# Lansdowne 2.0

NEW NORTH SIDE STANDS  
URBAN DESIGN BRIEF

DECEMBER 6, 2024

## RESPONSE TO URBAN DESIGN DIRECTIONS PROVIDED AT PRE-CONSULTATION MEETINGS WITH CITY STAFF

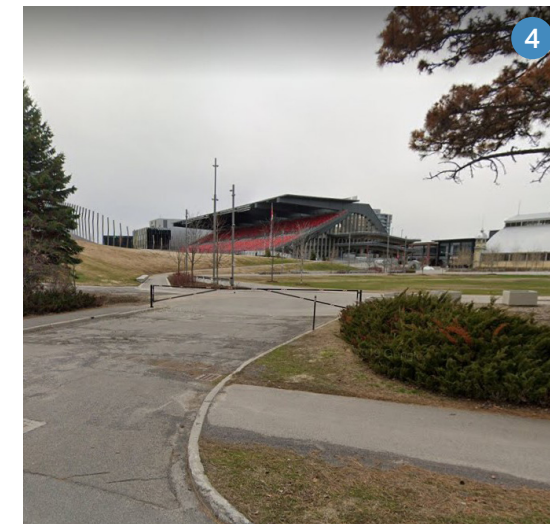
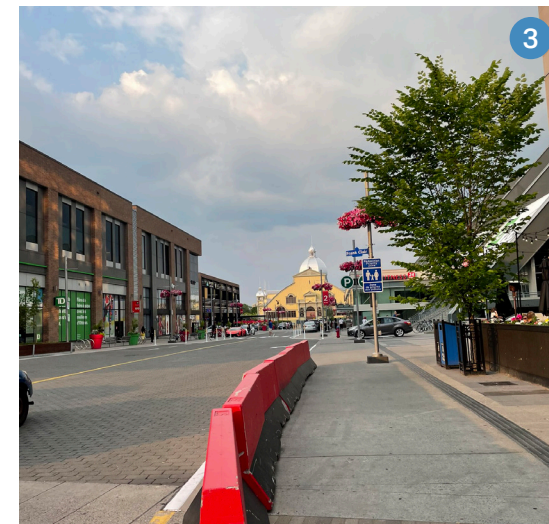
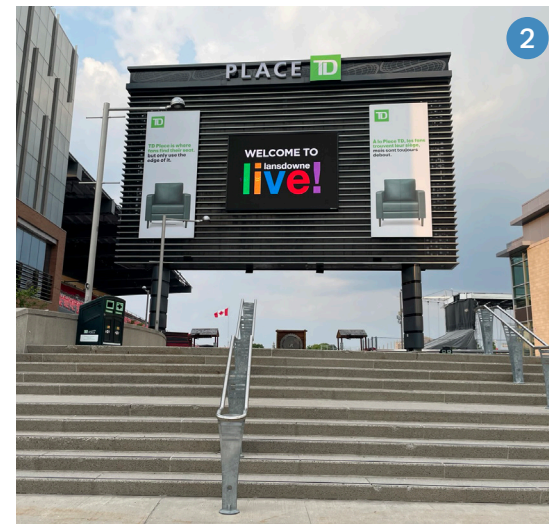
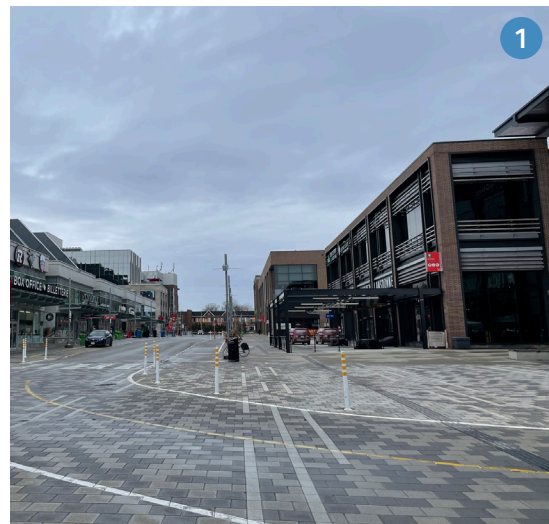
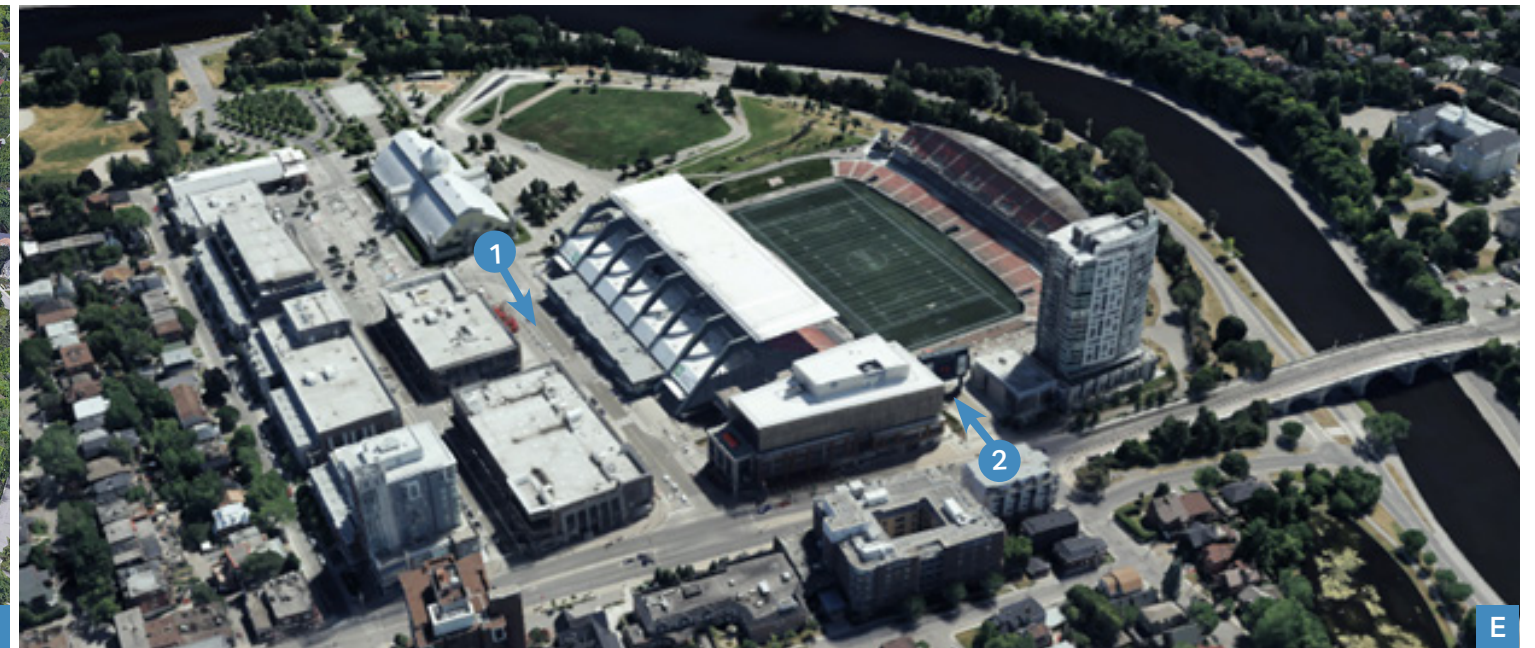
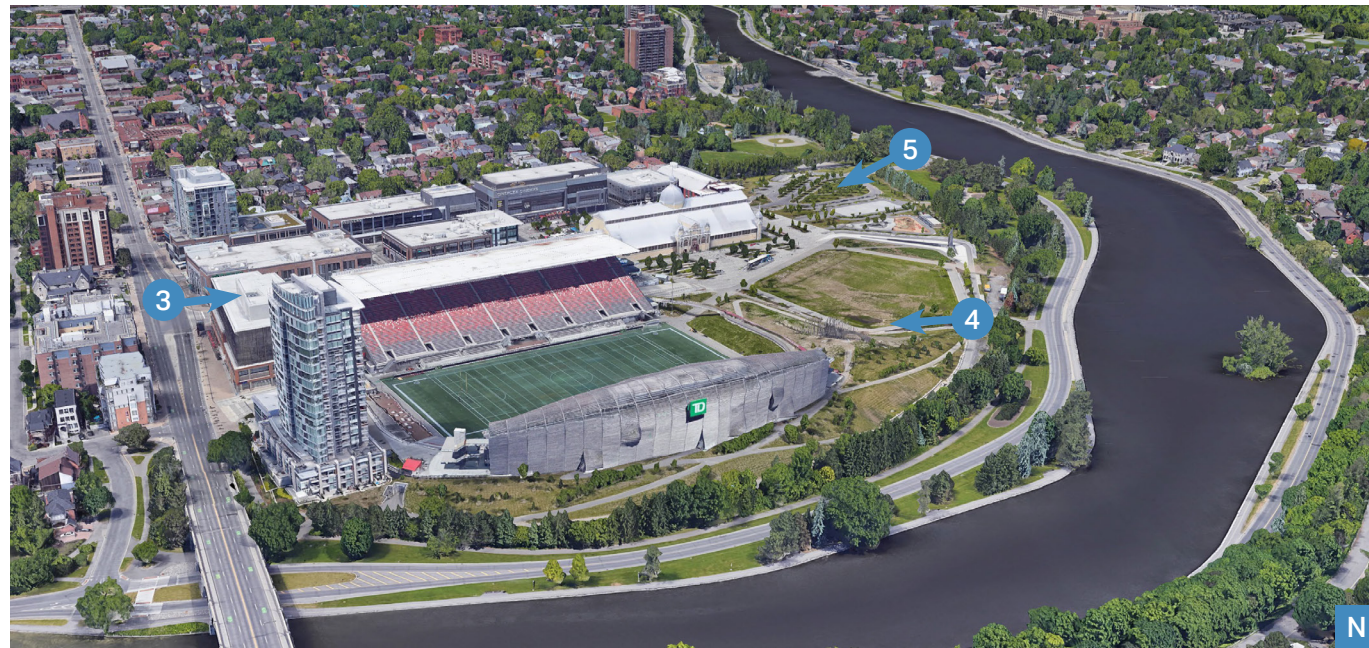
PRE-CONSULTATION MEETING COMMENTS		
NO.	COMMENT	RESPONSE
<b>PLANNING</b>		
1	Staff strongly encourage further consideration be made into ensuring a harmonious interface between the proposed north side stands and future mixed-use podium and tower. Efforts should be made to mitigate any negative impacts between the two land uses, including but not limited to:	
2	The ground-level laneway (previously a public promenade) should be designed with CPTED principles in mind, creating a pedestrian-friendly and animated area. Currently, it is staff's understanding that this area will functionally operate as the back-of-house for the commercial uses in the future podium. However, the area should be designed to positively integrate and connect with the remainder of Lansdowne Park, and incorporate glazing and quality surface treatment to resemble an active, safe, and visible component of the public realm.	To create the ground-level laneway designed with Crime Prevention Through Environmental Design (CPTED) principles, we carefully designed the facade with several key features. Downlights were installed at the columns to illuminate the walkways, enhancing visibility and safety. Additionally, CFL banners were incorporated to add both visual interest and lighting. To further enhance the openness and transparency of the space, we included glazing in the facade of the OSEG office, which helps alleviate its appearance and contributes to a more welcoming and secure environment.

3	Ensure that the height of the proposed north side stands, as well as the proposed northern elevation does not negatively impact the south-facing units within the future residential towers, ensuring adequate separation and views.	Proposed height is well within the approved maximum height for the lot. North stands are separated from the proposed towers by a distance of 15m. New North Stands is +/-1.5m higher than the existing North Stands.
4	Please consider revisiting the design of the north side stands in order to better represent Lansdowne Park's identity as a dense, urban entertainment district requiring architectural merit and integrity. The skeletal nature of the current proposal could be studied further in an effort to better contribute to the historical and cultural significance of the surrounding area and interface to future phases of the development.	We have provided a new landscaping design that enhances the overall aesthetic and better integrates with the surrounding environment. By partially covering the existing ramp to the underground parking on the West end, we create more opportunities for landscaping at grade, while adding an accessible entry and drop off area that is currently lacking from Frank Claire Lane. The design has evolved from the original concept to ensure a stronger connection to the site's historical and cultural context. While the design was considered as a modern evolution of the sturdiness of the existing stands, we have thoughtfully evolved it to better align with the surrounding environment, integrating modern elements with the existing conditions of the site. Additionally, we have incorporated curved architectural elements that not only complement the adjacent Event Centre but also align with the design of the stadium across, creating a more cohesive and unified identity for the area.

5	Please investigate opportunities to better treat the east, west, and northern facades to incorporate architectural elements which can screen the functional elements and activate the facade.	We are no longer providing mechanical equipment screens. Instead, we have extended the parapets to naturally conceal the equipment, ensuring a cleaner, more integrated look. This approach allows us to maintain a streamlined, cohesive aesthetic while addressing the need to screen functional elements.
6	Please describe the interim treatment of the north facade during the period of time starting after completion of the north side stands until the construction of the phase 3 residential towers.	BBB: N/A

NO.	COMMENT	RESPONSE
<b>URBAN DESIGN</b>		
	<p>East facade and relationship with the future plaza, the Aberdeen Pavilion and the new event centre is a concern. Back of house functions are proposed at grade on the east side. Much of the east side of the structure also appears to be “facade-less” where a very large storage space is secured by chain-link fences. The future plaza is an important public space and should be animated and/or well landscaped. Please consider the following:</p> <ul style="list-style-type: none"> <li>a. Allocate uses that can animate the plaza.</li> <li>b. Provide appropriate landscaping.</li> <li>c. Enclose the space under the stand and create a facade.</li> </ul>	<p>We have added an elevator lobby and Gate 4 entry at the east end, designed to better connect with the adjacent event center and the future plaza. We are no longer providing chainlink fences or storage spaces as initially proposed. Instead, the east facade is now enclosed with metal panels, enhancing the aesthetic appeal and creating a more cohesive and visually engaging interface with the plaza. Additionally, we are considering uses that will animate the plaza and provide appropriate landscaping to ensure the space is vibrant and inviting for the public.</p>

<p>Height and location of the north stand and relationship with future development along Exhibition Way is a concern. The total height of the proposed north stand is 29.952m, which is approximately 9m taller than the concept shown in the master plan. The north stand is also significantly closer to the potential future mixed-use high-rise development. The overall relationship with the future development may be significantly impacted when compared to the concept shown in the master plan, resulting in concerns on the impacts of the north stand on the viability and livability of future development, particularly the residential aspect of the development.</p>	<p>The zoning on the site permits a height of 38 metres. This was not changed through the previous OPA/ZBLA applications approved in November 2023.</p>

2.6	<p>In addition, the previously proposed pedestrian promenade is no longer contemplated. The applicant also indicated that Gate 3, which is an iconic feature of the master plan, is not a necessity for the operation of the north stand. These proposed and potential changes raise questions and concerns on the overall vision, connectivity, and public realm interface of the proposal.</p>	<p>The stands are well connected on the east with the pedestrian plaza and on the west with Frank Clair Lane, where the drop-off area and pedestrian Gate 2 entry are located. A placeholder for the future Gate 3 stair has been provided, allowing for its inclusion in later phases of development.</p>

2.7	<p>Relationship with developments on Bank Street is a concern. Comparing with the current condition, the proposed north stand will protrude into the background of the existing plaza on Bank Street between the two buildings. How will the “facade-less” design of the north stand look like from Bank Street? Similarly, at a height that is equivalent to a 9-storey building, the proposed stand will be highly visible from Exhibition Way. How will the “facade-less” design impact views from the Exhibition Way?</p>	<p>The proposed north stand is 1.5 meters higher than the existing structure, which will slightly alter its visibility from both Bank Street and Exhibition Way. However, the design is no longer “facade-less.” The east, west and north face of the New North Stands are now enclosed with metal panels and features vertical elements like railings, ensuring a more cohesive and visually appealing appearance. These updates address previous concerns and enhance the overall aesthetic. For a clearer understanding of how the design will look from these vantage points, please refer to the west renderings, which provide a more detailed perspective of the stand’s integration with the surrounding environment.</p>

2.8	<p>Wind conditions on and around the north stand should be further studied given the changes to both the north stand design and the zoning provisions for the future private development along Exhibition Way. Spectators should be safe and feel comfortable to sit and move around.</p>	<p>Completed wind study by Gradient Wind attached</p>

2.9	<p>The main concourse of the north stand is set at over 9m above grade, which is approximately 2.5m higher than previously envisioned in the master concept plan. Climbing up to the main concourse is equivalent to walking up to the 4th floor of a residential building. Is it too tall?</p>	<p>To address the height of the main concourse, we are providing a maximum of 15 steps per flight to ensure a manageable and comfortable ascent for visitors. Additionally, if elevators are required, we have incorporated two passenger elevators for patrons—one located at the west drop-off and another at the east drop-off. This design ensures accessibility and convenience for all users, making the height of the main concourse more manageable and accommodating.</p>

2.10(a)	<p>With three major projects in a row, the event centre, the north stand, and the mixed-use highrise development up to 40-storeys, Lansdowne Park Special District is likely to experience a prolonged period of construction activities. What is the plan to mitigate the impacts so that the District can continue to be a viable and vital destination during and after the construction? It appears that the north stand and the mixed-use high-rise development are intertwined by virtue of their location and close proximity, is there a plan to bundle the two projects so that the design can be integrated, and the construction can be coordinated?</p>
